Product hierarchy no. *	Part no.	SBU	Type / Description	Customer part no.			
SBU PG PUG Type							
01 002 002 0000000501	See list below	Fuseholder complete	FPG2	n.a.			
*SBU (2-digit) / PG (3-digit) / PUG (3-digit) / Type (10-digit)

- Change of material
- Modified label
- Improved electrical rating

Product Change Notification				FPG2 plastic material change				
owner	creation date	release date	released by	change order no	rev	page	D40 040 620	
zbindeja	2016-11-08	2016-11-16	nowakfr	2011423	Α	1 of 2	D10-010-638

## 3 Detailed description of change

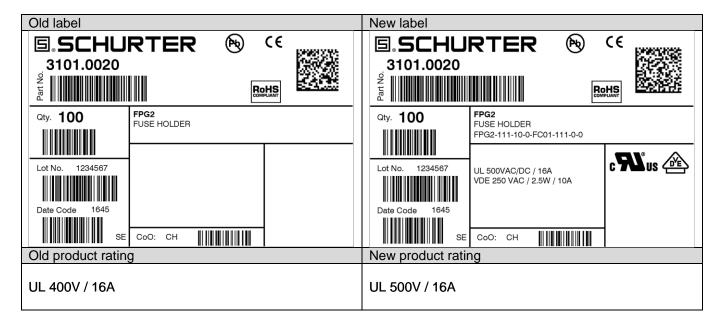
Form Yes Change of plastic material Fit No No change for dimension

Function Yes Improved electrical rating from 400 V to 500 V (UL)

Manufacturing No No change for manufacturing site
Label Yes VDE and cURus marks added

Electrical ratings added Configuration code added

- Product improvement to fulfil the enhanced glow wire requirements according to the updated standard IEC 60127-6 and the standard IEC 60335-1 for appliances in unattended use.
- Recertification by VDE
- Recertification by UL
